Approved for access by the Solid Waste Department.

Reviewer: Herman Gallegos

Date: 04-17-24

DUNKIN RESTAURANT 310 AVENIDA CESAR CHAVEZ SW ALBUQUERQUE NM 87102	SITE PLAN	PROJECT NO. 23-008
--	-----------	--------------------

C1.1

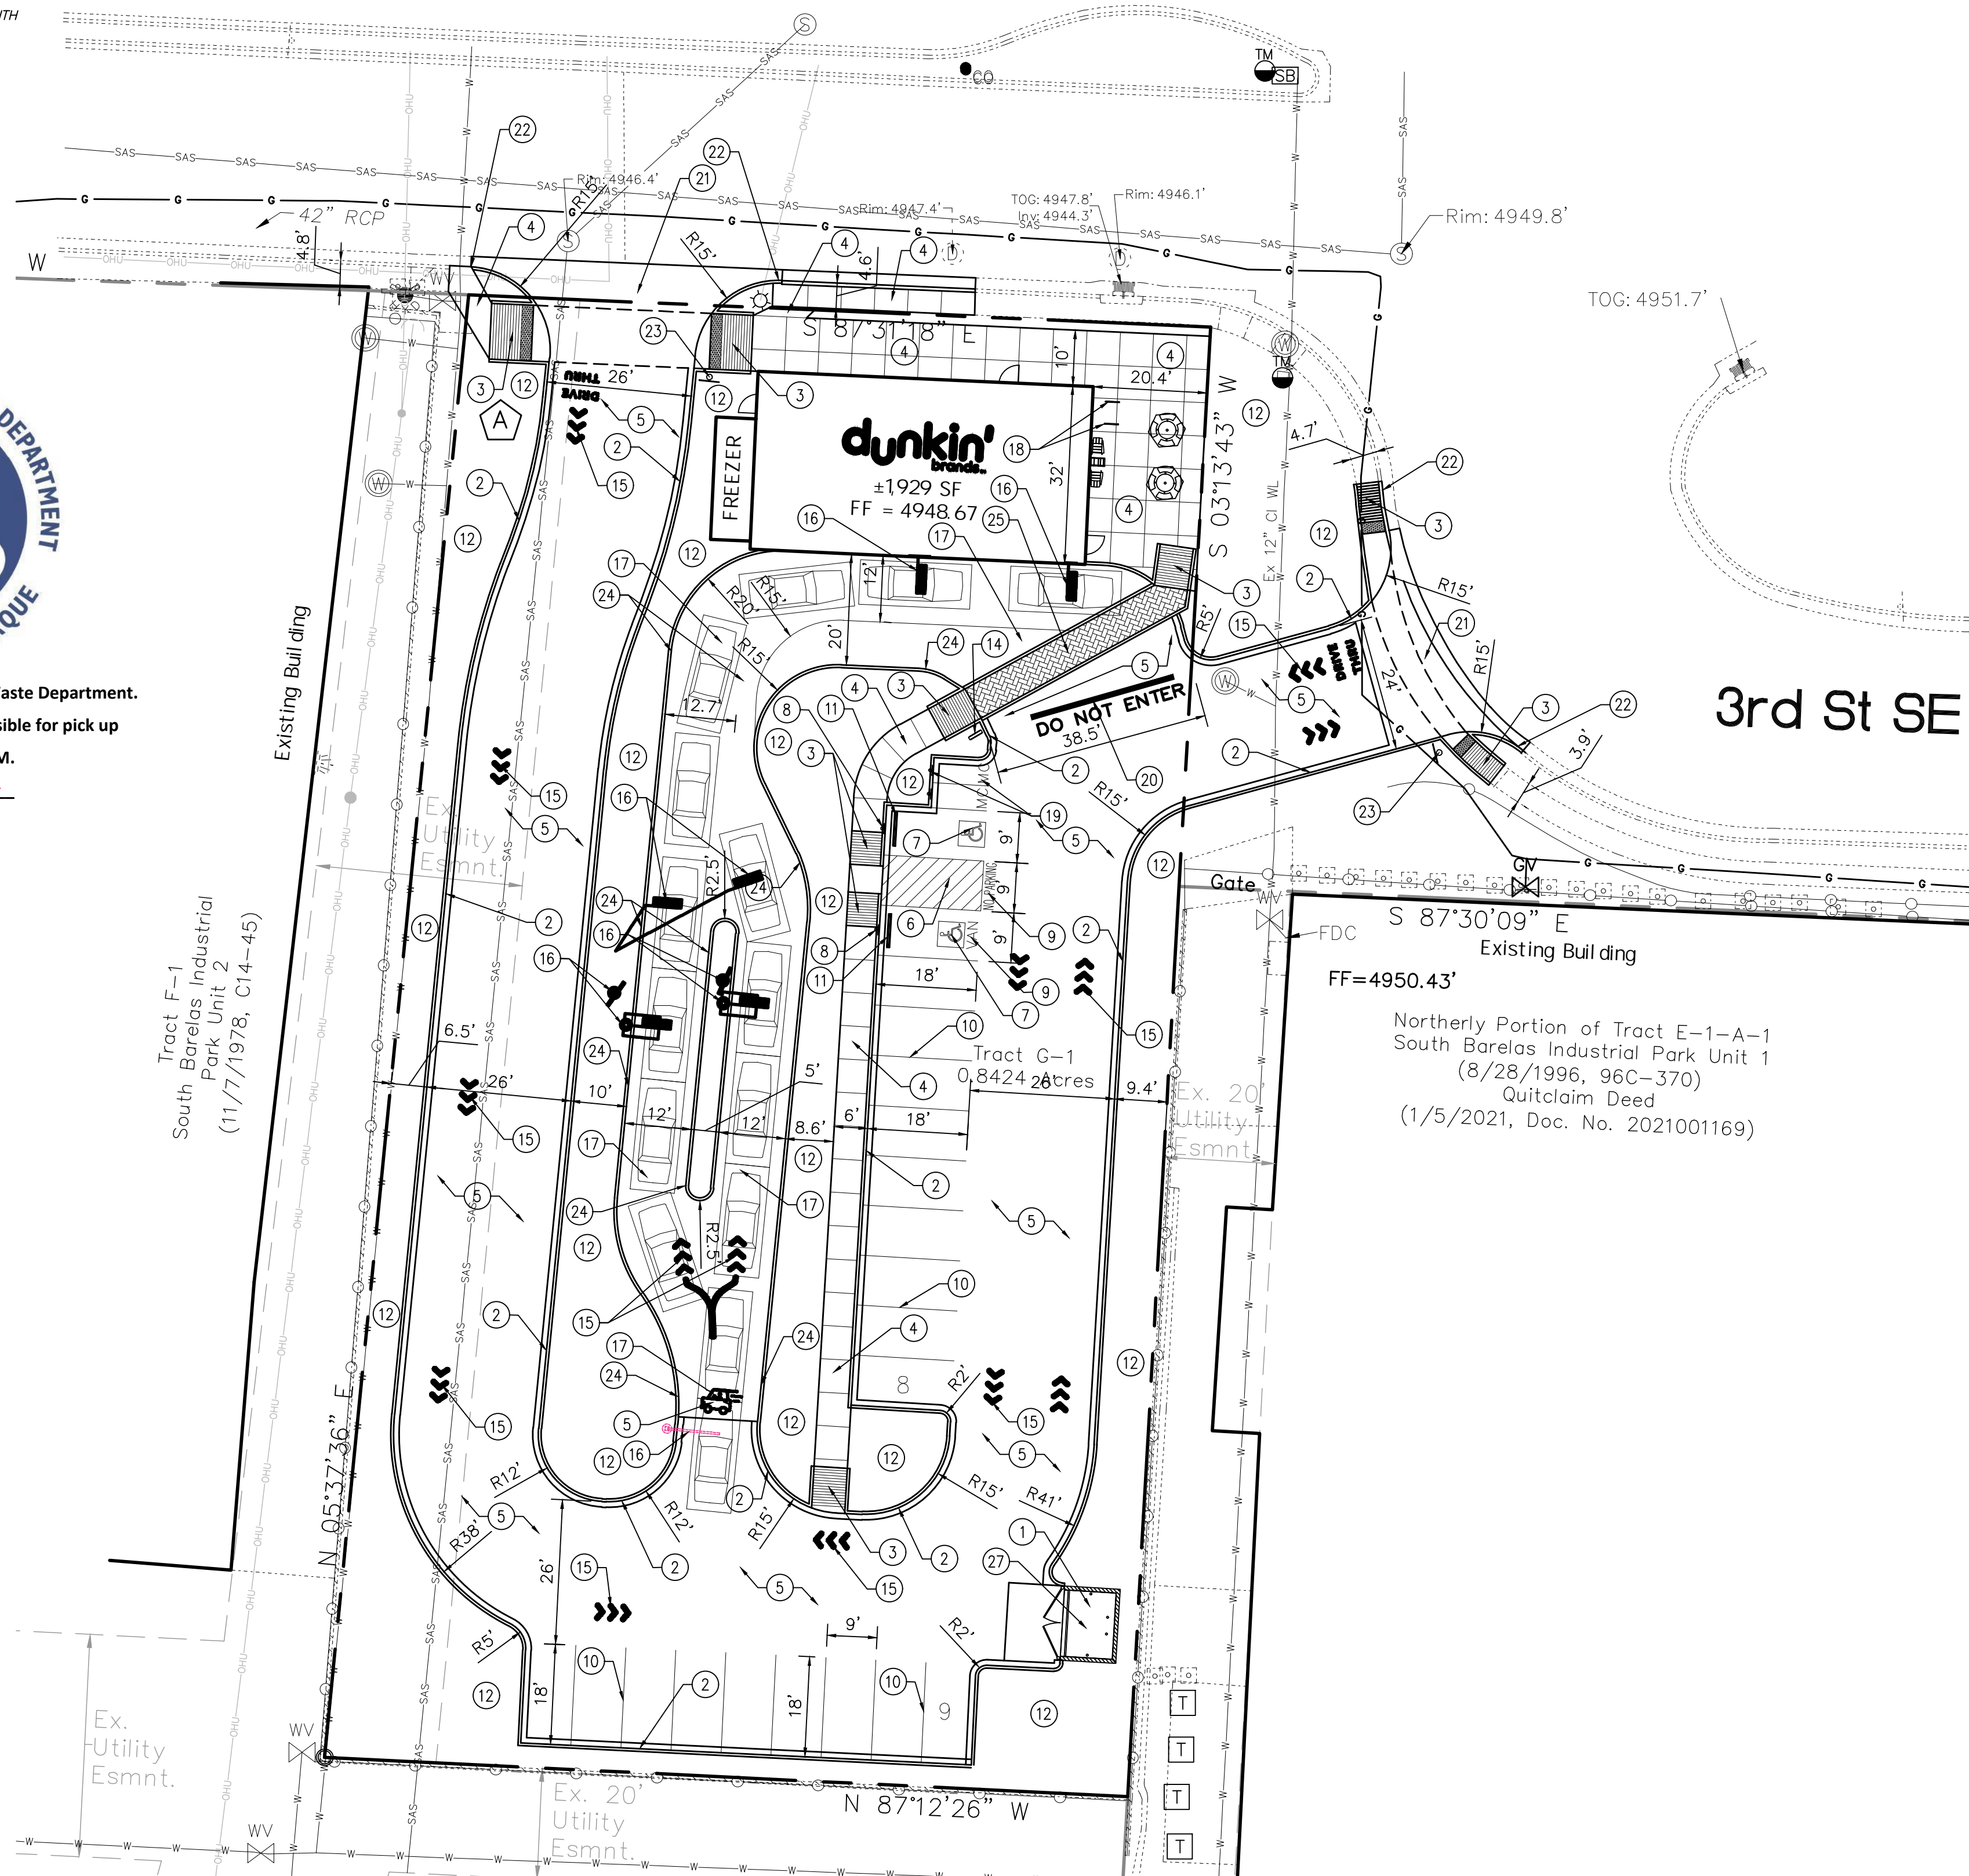
All containers must be made accessible for pick up between the hours of 5AM and 8PM.

****Recycling Declined****
